## 2020-07 BAR Decision for 120 Oakhurst Circle

BAR 20-07-03

120 Oakhurst Circle

New driveway and parking

Existing fence

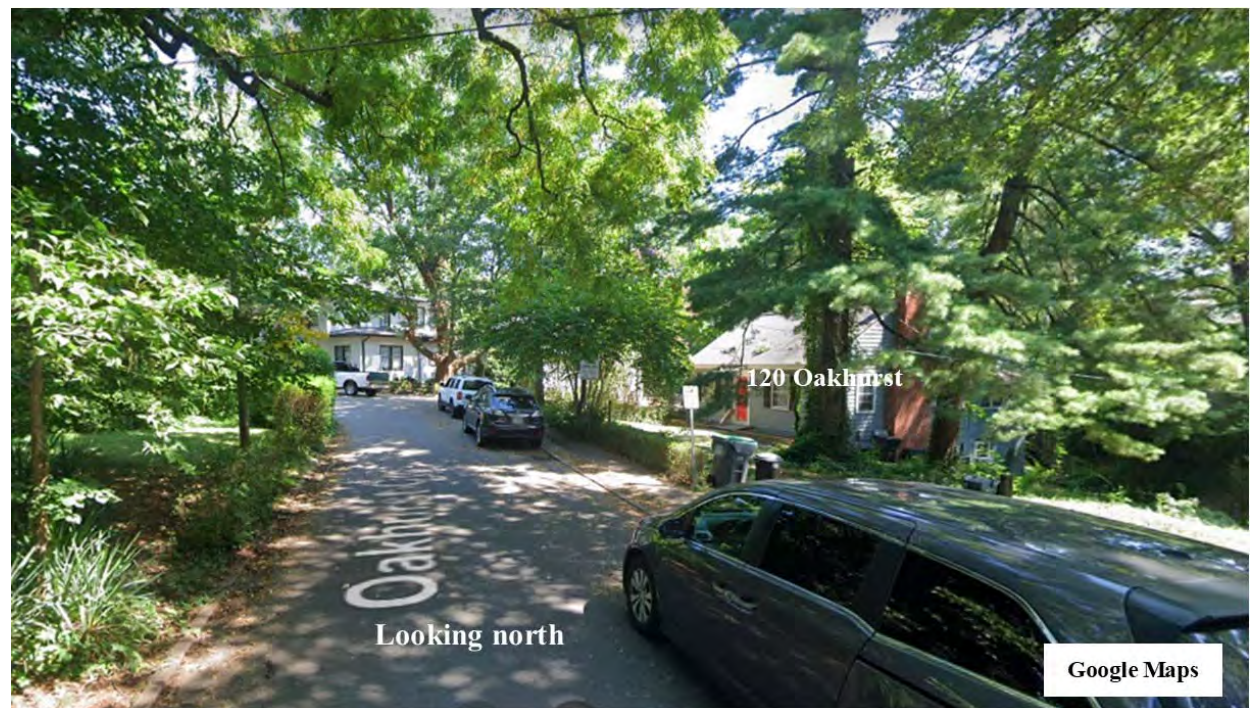
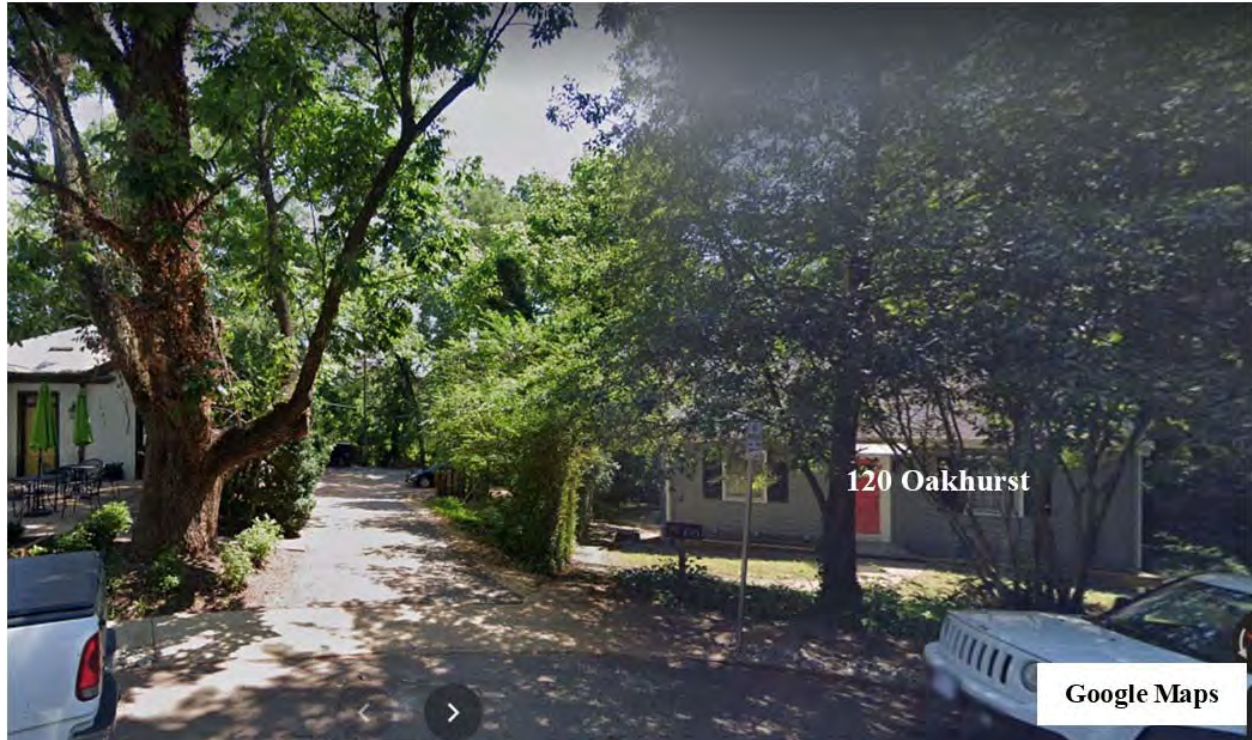
The new fence will replicate the existing at the south parcel line. That fence is unfinished, vertical, 1 x 6 boards—see photo in appendix.

## SITE PLAN

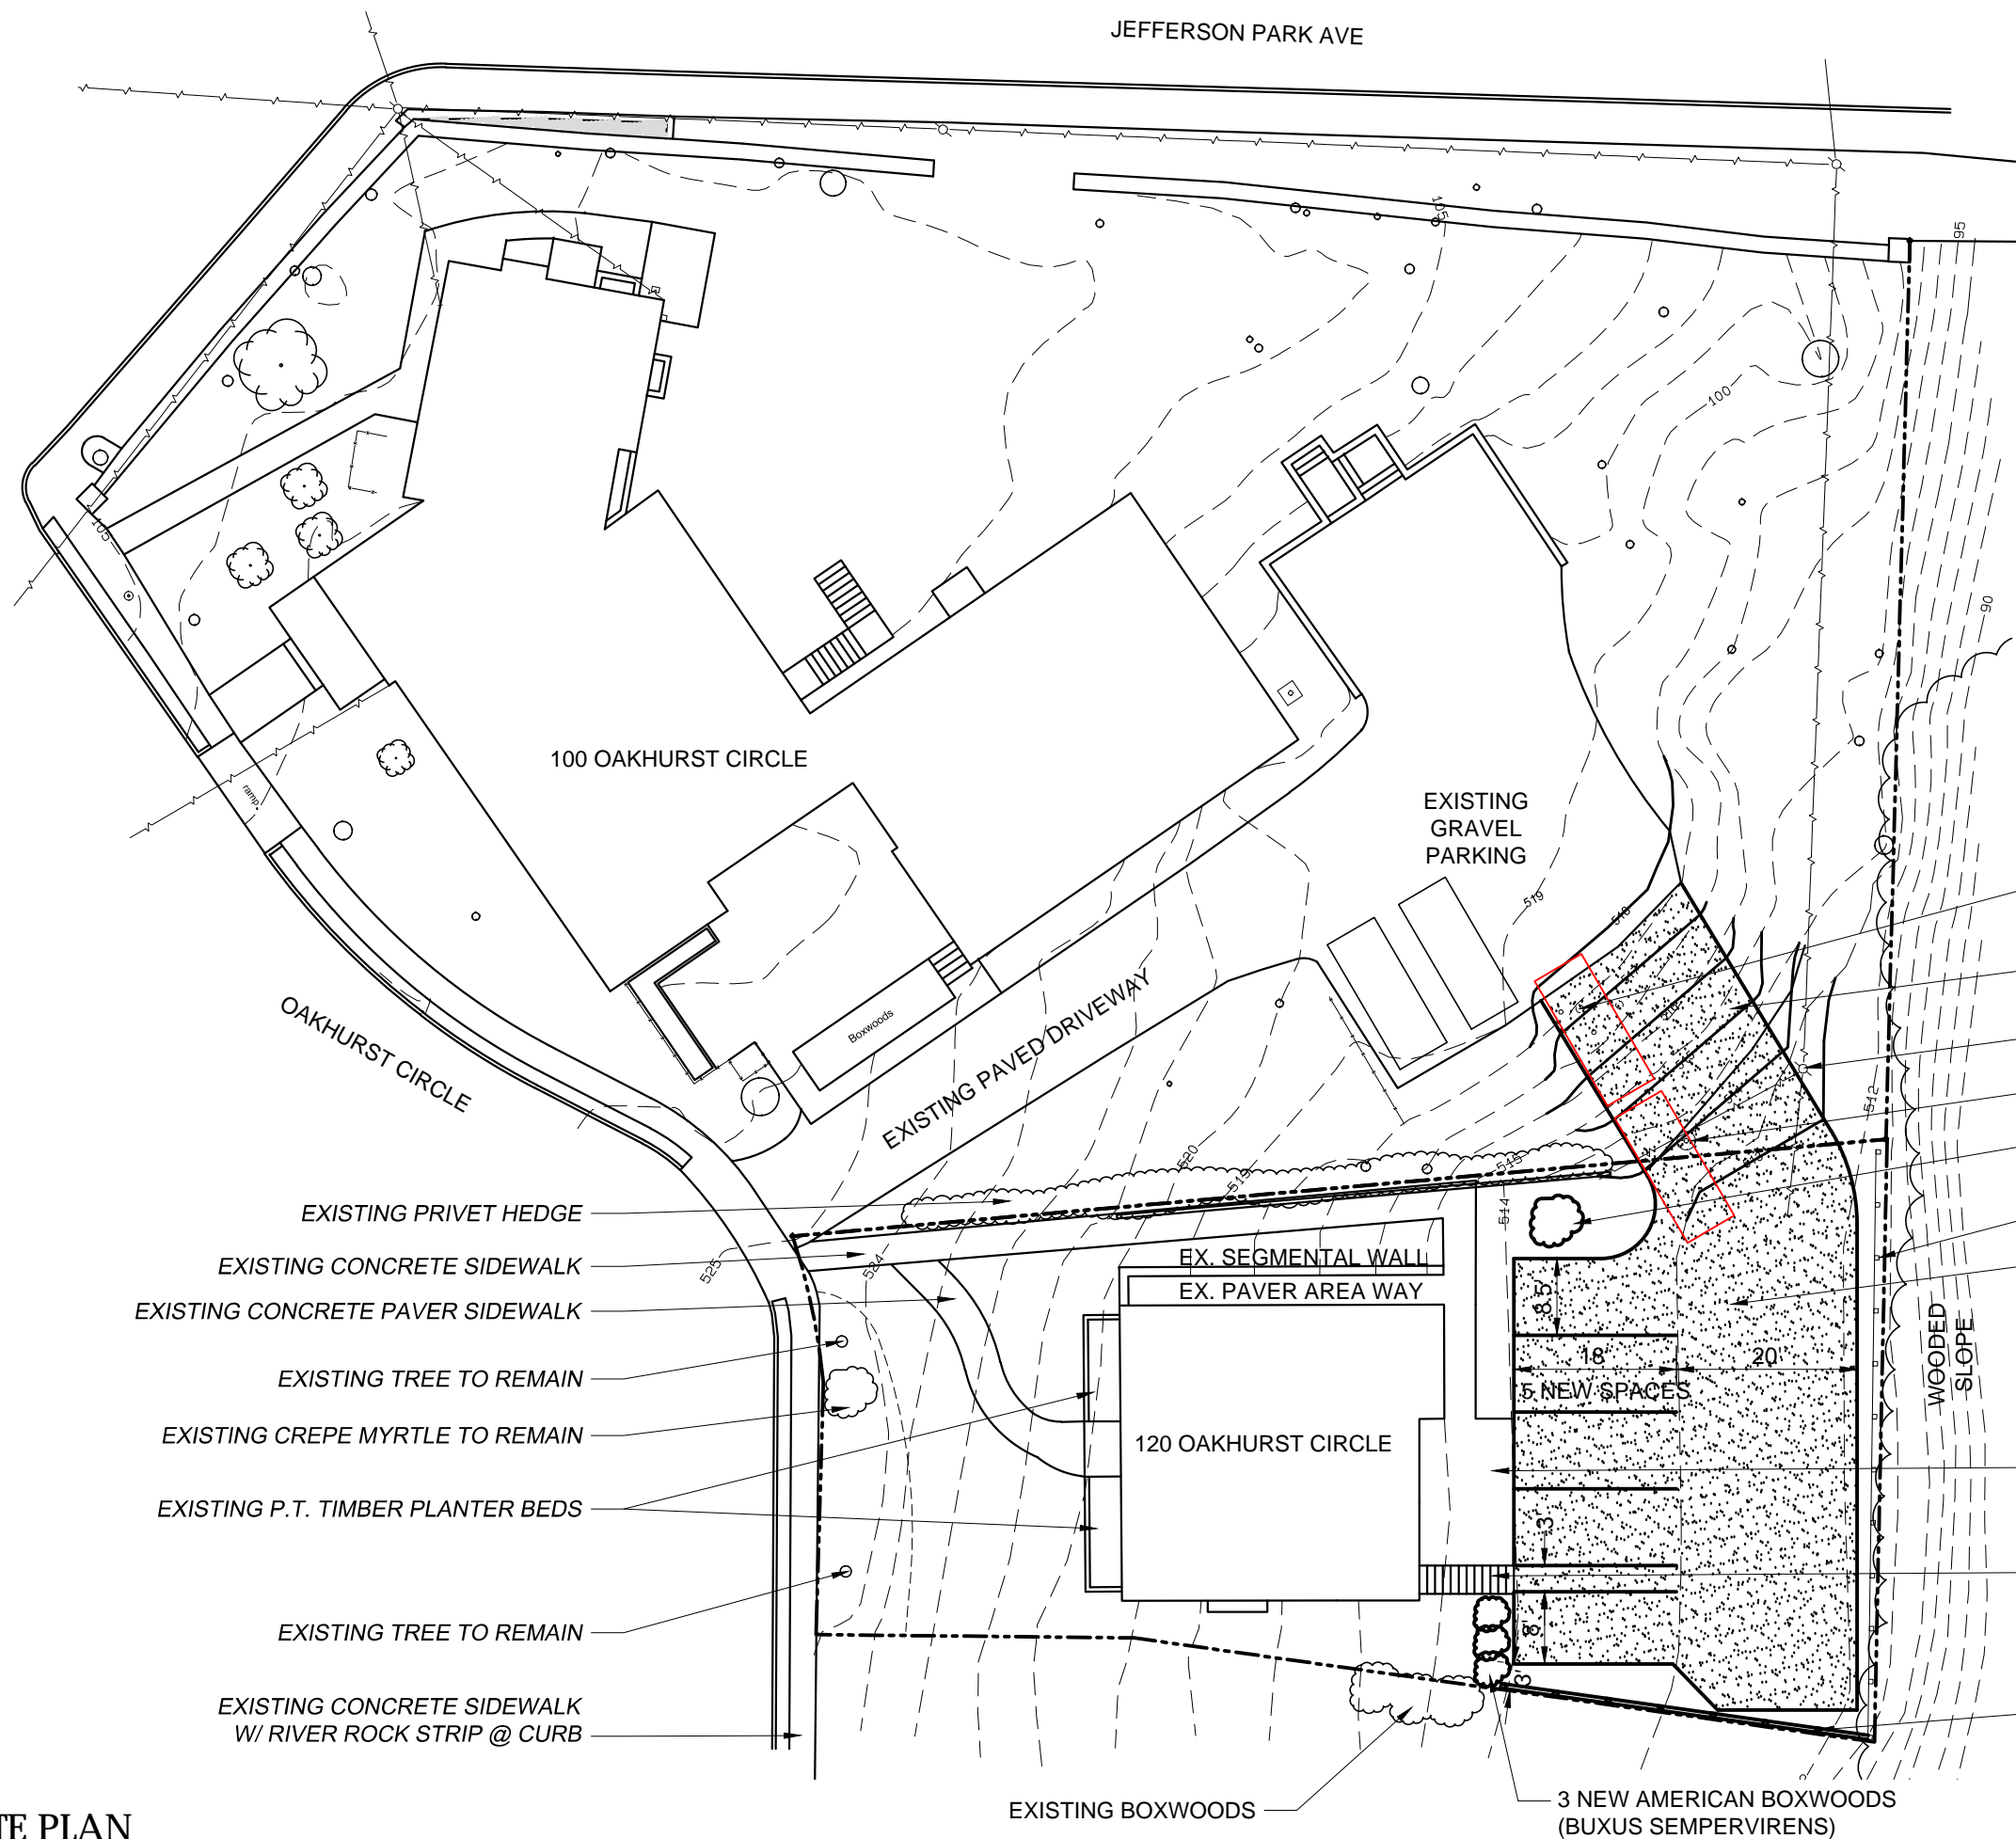
Request for CoA to construct parking area at rear of parcel, to be accessed by existing driveway on neighboring parcel. New parking surface to be Turfstone pavers. (This is in lieu of the pea gravel noted on the drawing.) Access will require removal of two locust trees and slight regrading of the slope. A 6-ft high wood fence approximately 40-ft in length will be constructed on the south parcel line, screening the parking area. (New fence to match the existing at the rear parcel line. See appendix.) To further screen the parking area, three American boxwoods (*Buxus Sempervirens*) will be planted at the south side and a crepe myrtle (*Lagerstroemia Indica*) will be planted at the north side.

120 Oakhurst Circle is a non-contributing structure, the proposed alterations are entirely to the rear of the house, well below street level, and the ADC District does not extend beyond the rear parcel line. (The existing house is 6-ft lower than the street. The rear of the house is 16-feet lower.)

Staff recommends approval, with any proposed conditions regarding the fencing and/or the tree selection.
